Written submission from the Prince Albert Grand Council

**Regulatory Oversight Report for Uranium
Mines, Mills, Historic and Decommissioned
Sites in Canada: 2017**

Prince Albert Grand Council's written intervention regarding the Regulatory Oversight Report on Uranium Mines, Mills, Historic and Decommissioned Sites in Canada: 2017.

Photo of Gunnar Mine Site

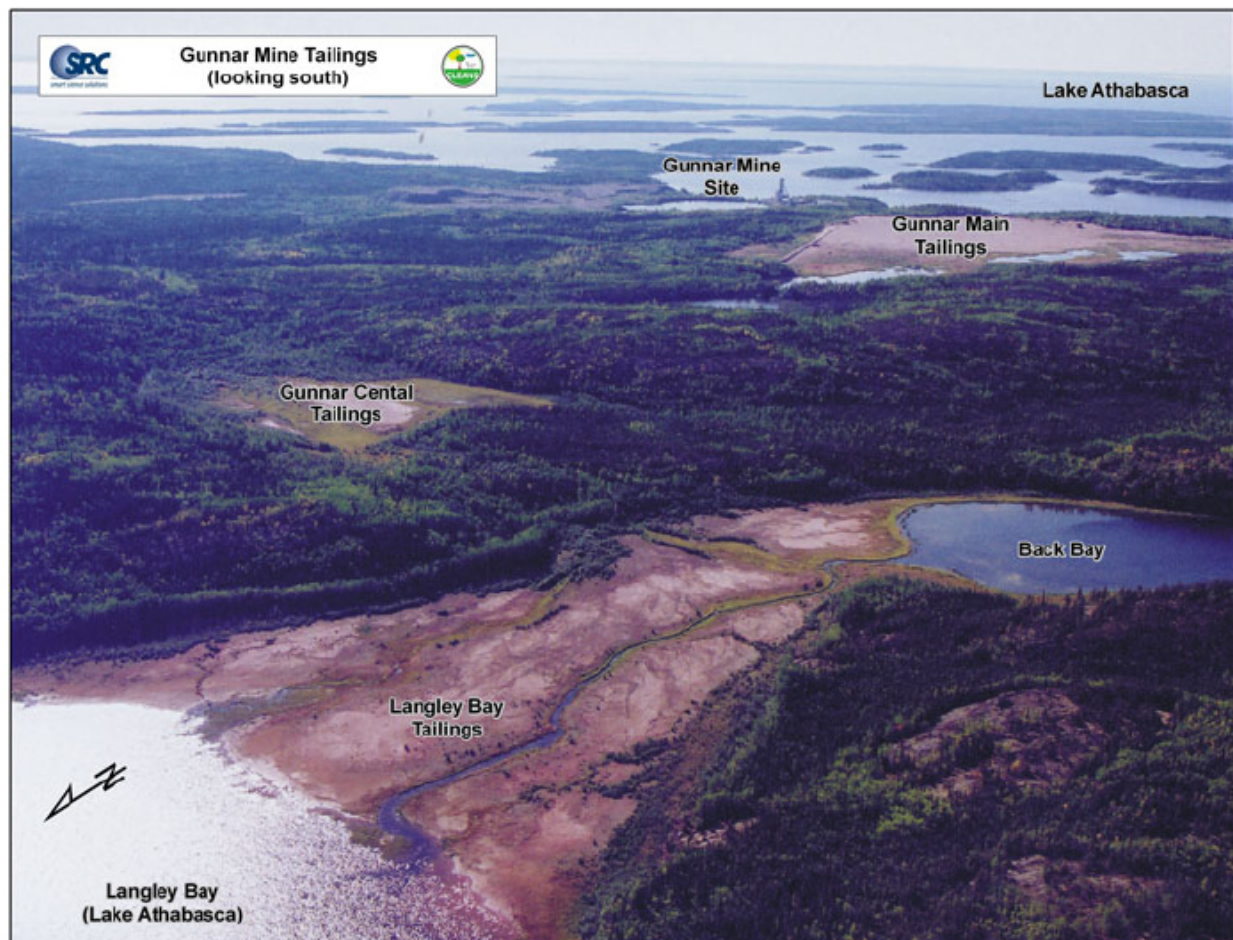
Flooding issue: Gunnar and other mines

ROR says there is no liquid effluent at the Gunnar site; however, there is overland flow and seepage from the site into local water bodies. (Page -115 of ROR)

Questions: What is the risk of flooding of this and other mines of the Black Lake, SK area? Do they have any flood mapping (**flood hazard risk assessment**) of the 37 uranium mines to measure the risk of overspill of mine pits or flooding of tailing ponds? Research says rainfall/precipitation rates may increase in Arctic and Mid-Arctic Canada) with the warming up of weather (See <https://www.enr.gov.nt.ca/en/state-environment/13-projected-trends-temperature-and-precipitation-arctic>)

Anticipation: We need to worry about the abandoned mines that did not go through any decommissioning processes and regulations were not strict as is the case for operating mines.
